33509B-02

Modification Recommended Service Note

33509B Function Generator

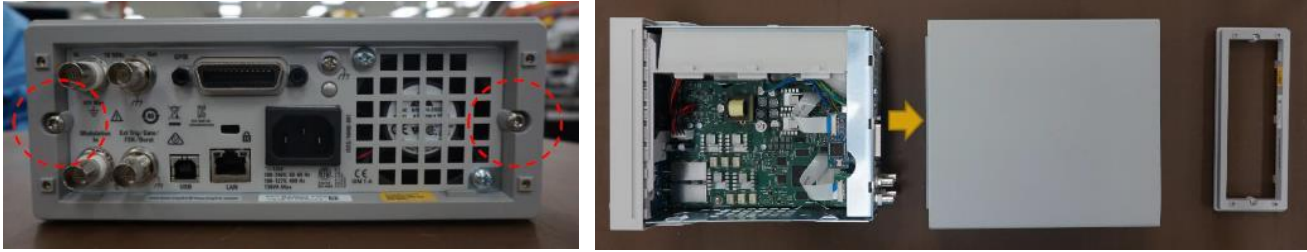
The Problem – Some customers have reported that, when line power is applied to the instrument but the instrument is NOT turned on (“Standby Mode”), some instruments will emit an audible high-pitched whistle or whine. To fix this, the existing power supply must be replaced with a newly designed power supply, as detailed in the solution below.

The solution is to replace the old power supply with a new one. The old power supply was manufactured by XP Power. The new power supply is manufactured by MeanWell, and has Part Number 0950-6082.

Old Noisy XP Power Supply (PN xxxx-xxxx)

New MeanWell Power Supply (PN 0950-6082)
